UPDATE CHANGE NOTIFICATION # 16380BGeneric Copy

Issue Date: 13-Jul-2010**TITLE:** Marking and Ordering Information Update for Gresham die based 2Kb I²C SPD EEPROM Devices (CAT34C02)**PROPOSED FIRST SHIP DATE:** 01 Aug 2010**AFFECTED CHANGE CATEGORY(S):** CAT34C02, Gresham Die (all packages, all temperatures)**ADDITIONAL RELIABILITY DATA:** n/a**SAMPLES:** Contact your local ON Semiconductor Sales Office**FOR ANY QUESTIONS CONCERNING THIS NOTIFICATION:**Contact your local ON Semiconductor Sales Office or Denisa Stefan
<denisa.stefan@onsemi.com>**NOTIFICATION TYPE:**ON Semiconductor will consider this change approved unless specific conditions of acceptance are provided in writing within 30 days of receipt of this notice. To do so, contact <quality@onsemi.com>.**DESCRIPTION AND PURPOSE:****Marking Update:**Package marking for CAT34C02, 2Kb I²C SPD EEPROM devices fabricated with Gresham die (presently offered under OPNs terminated with 'A') will be updated, as compared to the format previously published in FPCN 16380 in order to align the marking for these devices to the improved marking format most recently announced for 4Kb to 64Kb I²C devices fabricated with Gresham die (FPCN 1647

CAT34C02 Gresham die based marking, before and after August 1st, 2010

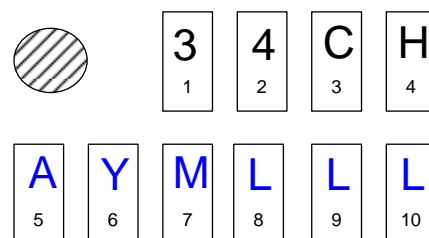
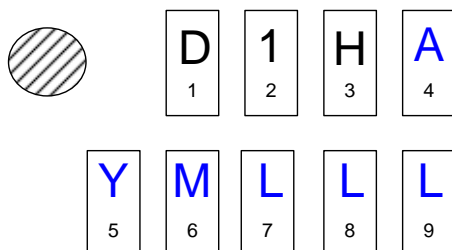
The new marking shown in the attached Appendix will be used starting with date codes containing August, 2010.

D1H / 34CH - device code for TSSOP

D1 / D1T, D1U, D1V - device code for TDFN/UDFN

M - Code for production month and assembly location (underline, etc. for assembly location)
